UPDATE PRIOR TO SALE NOTICE

Global Service Action
Number: D020 UPS2625-2

Subject: Rear Right Lamp Assembly - Cosmetic Defect	Publication No.: D020 UPS2625-2
	Model: Range Rover (LK)
	Model Year: 2025
	Date of Issue: 03 June 2025
	Expiry Date: 29 May 2027

SERVICE INSPECTION

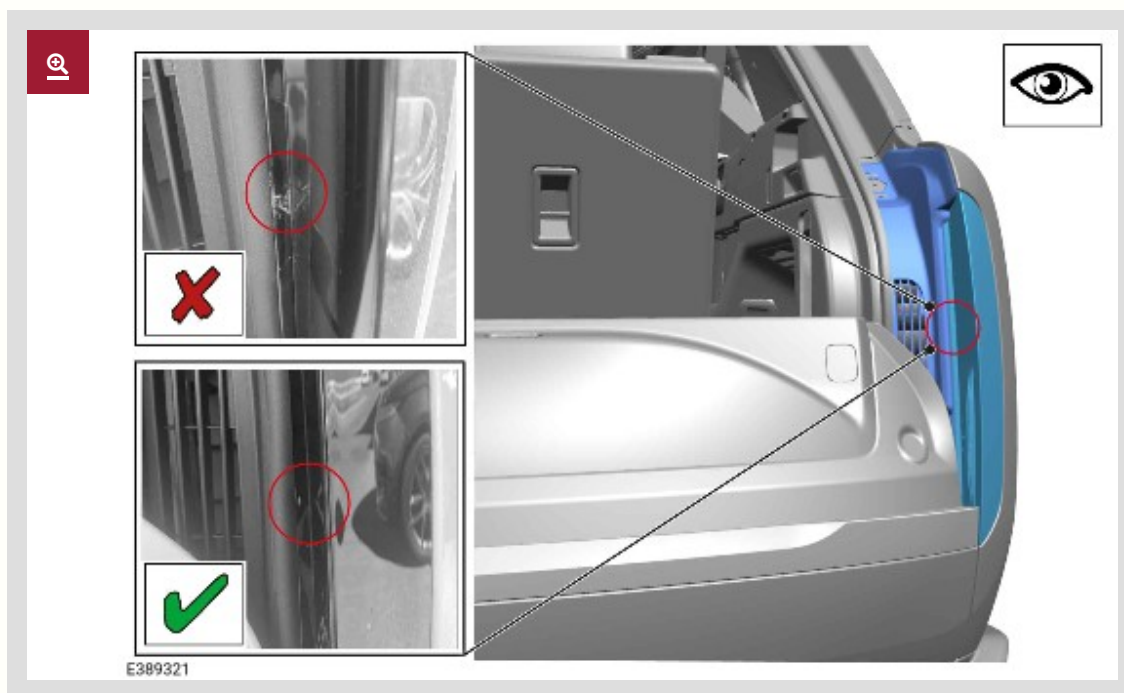
2. Inspect the rear right lamp assembly in the area shown in the illustration.

- If the rear right lamp assembly shows signs of cosmetic defects as shown in the illustration with the **RED X**, the inspection is a **FAIL**. Continue to the Service Instruction.
- If the rear right lamp assembly does not show any signs of cosmetic defects as shown in the illustration with the **GREEN**, the inspection is a **PASS**. Close the upper tailgate and release the vehicle.

1. Renew the rear right lamp assembly (see TOPIx Workshop Manual section 417-01: Exterior Lighting - Removal and Installation - Rear Lamp Assembly).
